July 6th, 2011

PCN for SMD kHz crystal, MC-146 taping and shipping spec

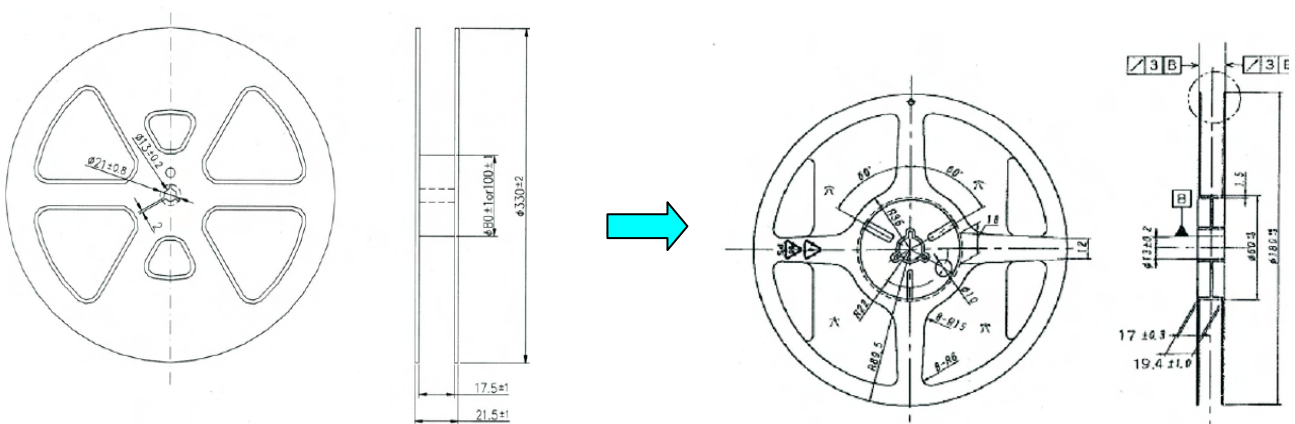
(1) Crystal unit loading pitch of taping will be changed from 8mm to 4mm.

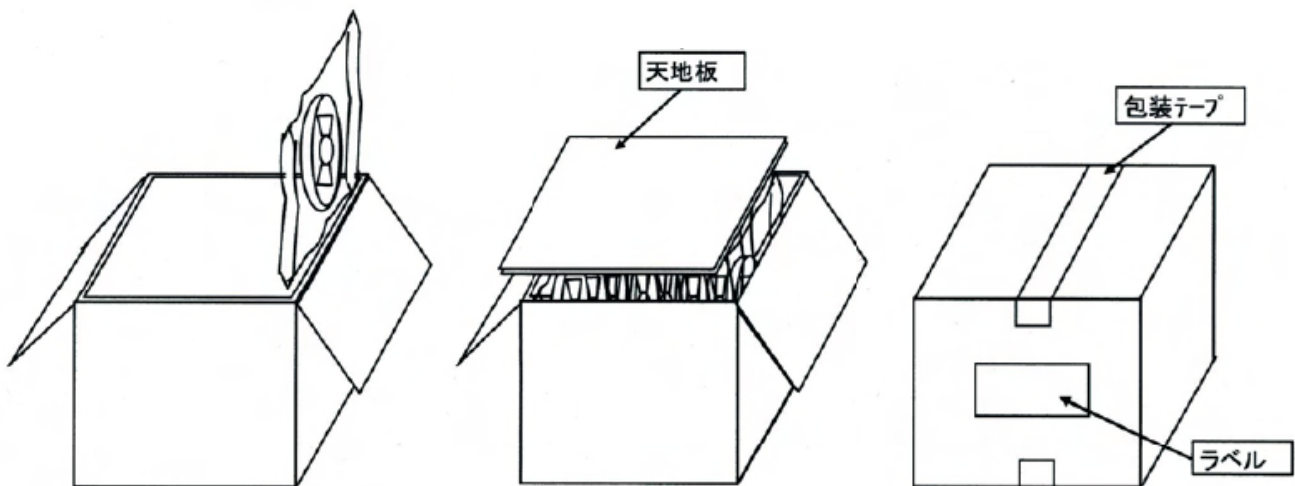
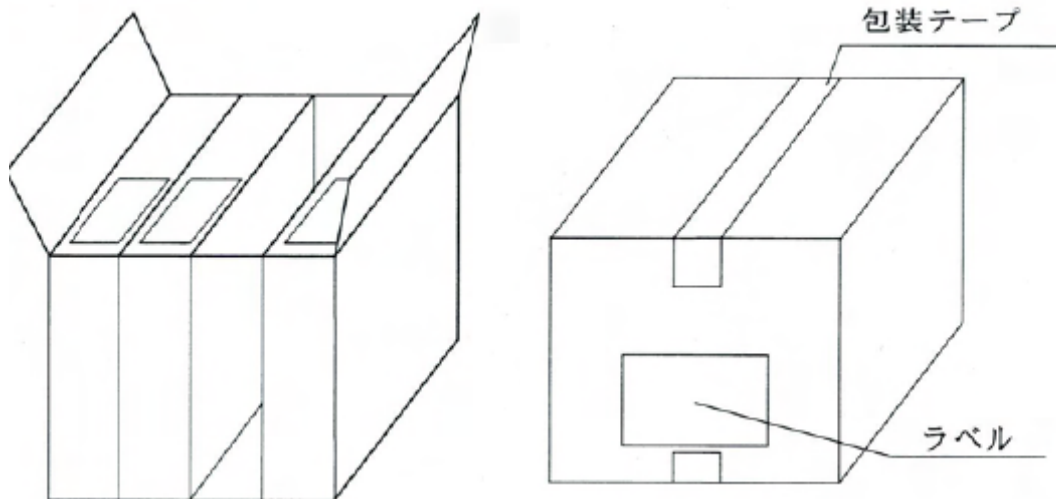
(2) Reel diameter changed from φ330mm to φ180mm.
